### 33.3.7.2 Input average power

#### 33.3.7.2.1 Input average power for certain Class 6 and Class 8 PD's

Figure 33–38—Type 1, Type 2, and single-signature PD static operating mask

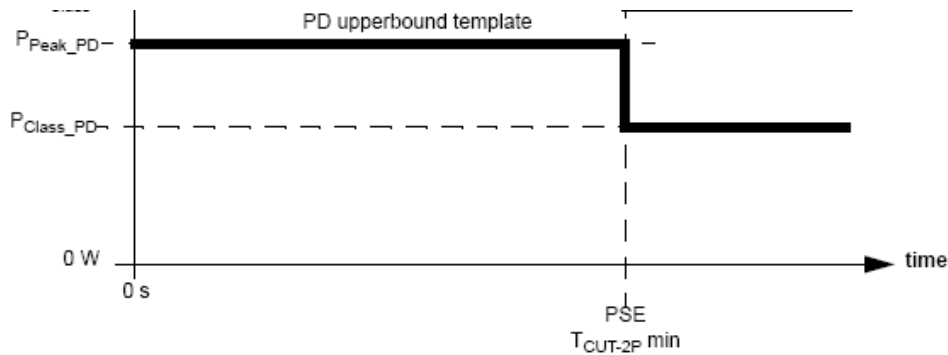
Under normal operating conditions when there are no transients applied at the PD PI, ~~Class 6 or Class 8 PDs, shall operate below the PD extended template defined in Figure 33–38.~~ Single-signature PDs, ~~of all other Classes~~ with the exception of those described in 33.3.7.2.1 and 33.3.7.4.1, shall operate below the PD upperbound template defined in Figure 33–38.

NOTE—PDs are required to meet Equation (33–2) which results in a slightly lower power and current than results from Figure 33–38, Figure 33–39, Equation (33–27), Equation (33–28) and Equation (33–29).

*(This last line is deleted because PD's must meet  $P_{Class\_PD}$  with or without  $P_{Peak}$  transients...)*

The PD upperbound template in Figure 33–38,  $P_{SSUT}$ , is described by Equation (33–28):

**Figure 33-40 – Class 6 and Class 8 PD's Described in 33.3.7.4.1**

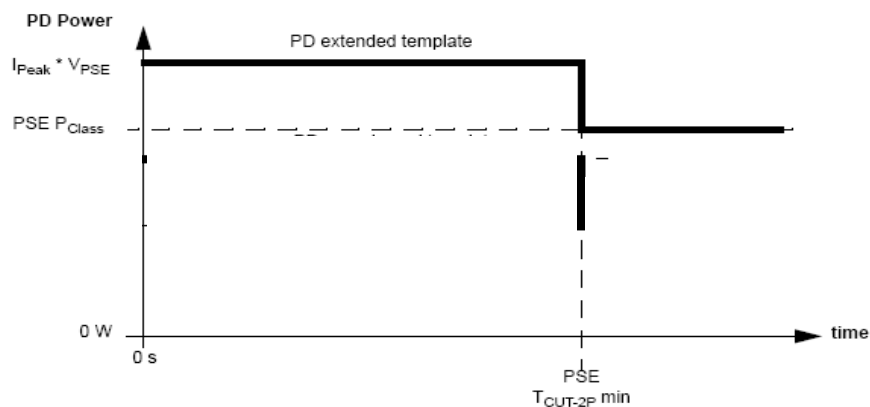
PSE's described in 33.3.7.2.1 and 33.3.7.4.1 shall operate below the PD upperbound template defined in Figure 33-40.

The PD extended template in Figure 33–40, PSSET, is described by Equation (33–29):
